DECO - USNRC DOCKET NO. 50-341

FERMI 2 CCHVAC DUCTING SYSTEMS

CONCERN ITEM NO. 19

EVALUATION CALCULATIONS

FIG. 2.1 TYPICAL STIFFENER CONNECTION FOR RECTANGULAR DUCTS (~~ANGLES~~ ANGLES *DBG* 6-1-94 LAPPED AND WELDED AT CORNERS)

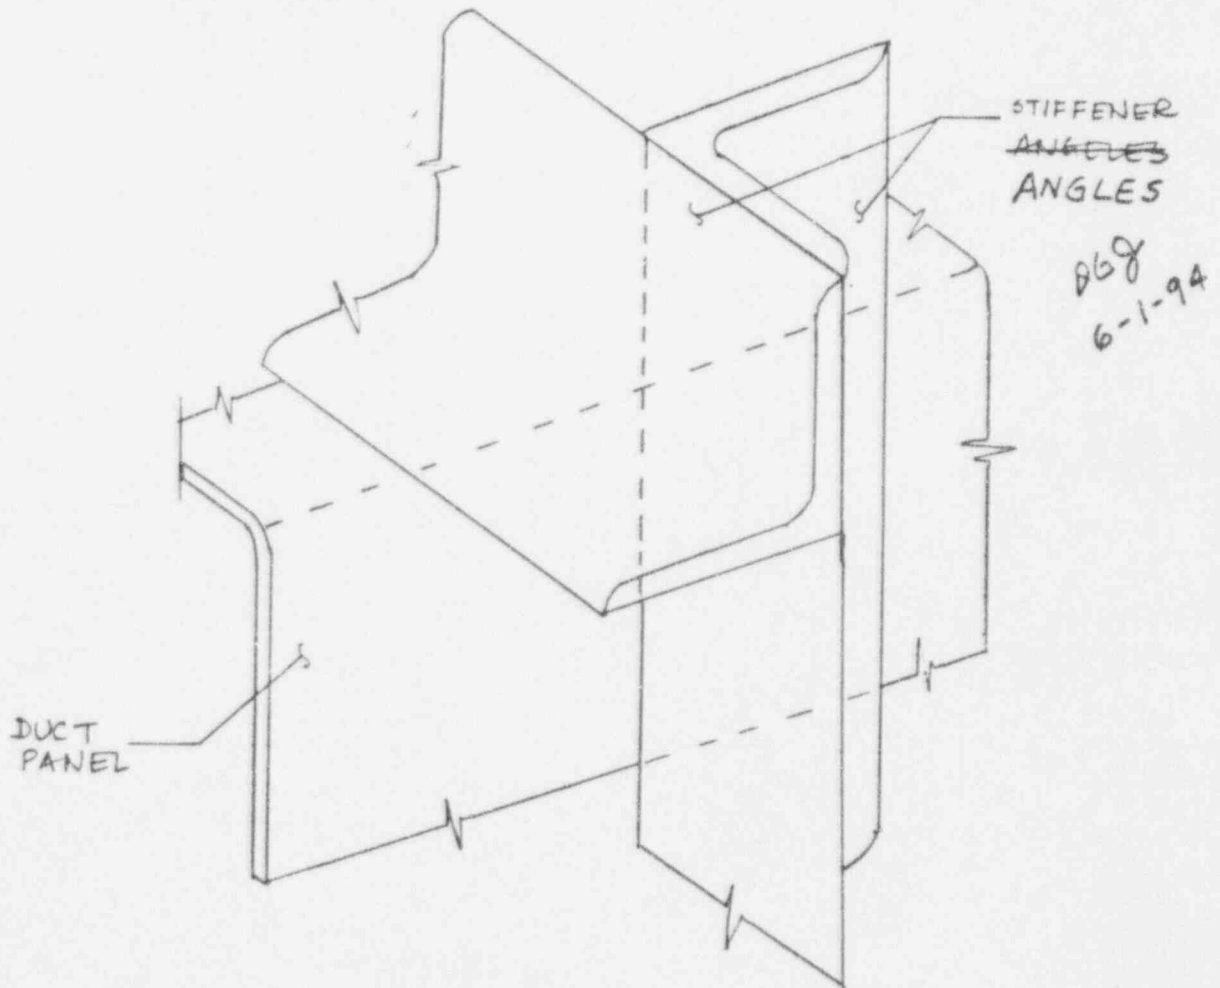
The analyses in this report address only the ductwork. No safety calculation of the supports, or calculated safety margins determined in such calculations have been reported. The design calculation report DC-5089 states that all hangers, stiffeners and supports meet the stress criteria of ANSI/ASME N509-80. No documentation has been provided to support this statement.

STIFFENER ~~ANGLES~~ ON ADJACENT PANELS ARE WELDED TOGETHER TO PROVIDE A MOMENT RESISTING CONNECTION [RECTANGULAR DUCTS]. A TYPICAL CONNECTION IS SHOWN BELOW:

1. THE STIFFENERS ARE SUBJECTED TO LOADING BY DEAD LOAD & INTERNAL PRESSURE ONLY, SEISMIC PANEL INERTIA IS NOT CONSIDERED SINCE THIS IS NOT THE GOVERNING LOAD CASE.
2. THE STIFFENERS ON ADJACENT PANELS ARE WELDED TOGETHER AT THE ENDS SUCH THAT THIS REPRESENTS A FIXED BOUNDARY.
